Access Compliance Report

Public Rights-of-Way

(Curb Ramps)

Intersection ID: 29393	Main Street: AMBERGLADES_LN	Cross Street: GOLD_PAN_RD	Location: NE
ADA ID: 7FB048B459CA	Ramp Type: PerpDiag	Initial Pass/Fail: Pass	Overall Compliance: No
Severity Score: 5.25			
Codes/Mitigation Info/Possible Solution		Field Measurements/Component Compliance

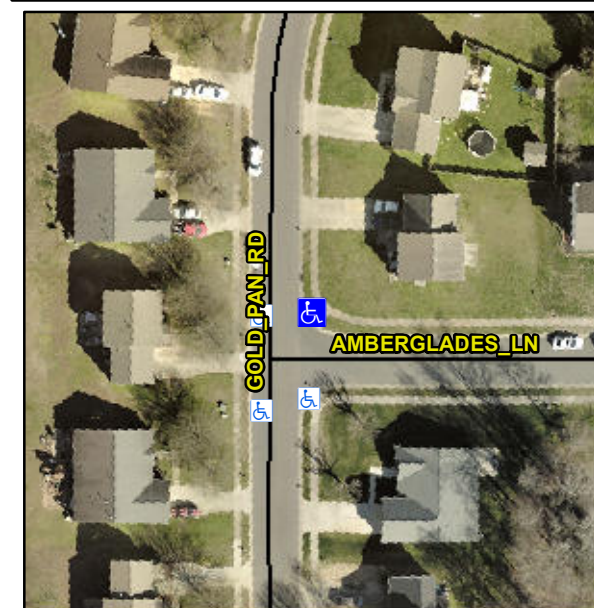
Not Found, R304.5.3, R304.2.1, R304.2.2-Perp, R304.3.2-Para, R304.2.3, R305.2

Compliance	Description	Data	Compliance	Description	Data
N/A	Ramp Length (in)	84.5	Yes	Ramp Slope (%)	8.0
Yes	Ramp Width (in)	48.0	No	Ramp XSlope (%)	3.2
N/A	Flare Type LT	Sloped	N/A	Flare Type RT	N/A
N/A	Flare Slope LT (%)	12.4	Yes	Flare Slope RT (%)	3.0
N/A	Flare Traversable LT?	Yes	N/A	Flare Traversable RT?	Yes
No	Landing Length (in)	43.5	Yes	DWS Provided?	Yes
Yes	Landing Width (in)	48.0	Yes	DWS Contrast?	Yes
No	Landing Slope (%)	6.1	Yes	DWS Length (in)	24.0
No	Landing X Slope (%)	3.2	Yes	DWS Full Width?	Yes
N/A	Landing Curb? (Y/N)	No	No	DWS Offset (in)	3.5
N/A	Shared Landing?	No			
Yes	Gutter Ponding?	No	Yes	Gutter Slope (%)	2.6
Yes	Gutter Lip Ht (in)	0.0	No	Gutter X Slope (%)	2.1
N/A	Painted X Walk1?	No	N/A	Painted X Walk2?	No
	X Walk 1 Direction	To W		X Walk 2 Direction	To S
N/A	X Walk 1 Width (in)	N/A	N/A	X Walk 2 Width (in)	N/A
	X Walk 1 Slope (%)	6.0		X Walk 2 Slope (%)	0.8
	X Walk 1 X Slope (%)	0.3		X Walk 2 X Slope (%)	2.8

N/A	Ramp inside XWalk1?	N/A	N/A	Ramp inside XWalk2?	N/A
	Road Slope (%)	3.1	N/A	Clear Space?	Yes
	Road X Slope (%)	5.8	N/A	Clear Space to XWalk (in)	N/A
Yes	Any Obstructions?	No	Yes	Storm Grate/Utility Hazard?	No
	Obstruction Type			Storm Grate/Utility Type	
		N/A			N/A
			Yes	Surface Condition? (G/P)	Good

Remove & Replace Curb Ramp With Two New Directional Ramps or Equivalent. Remove & Replace Gutter.
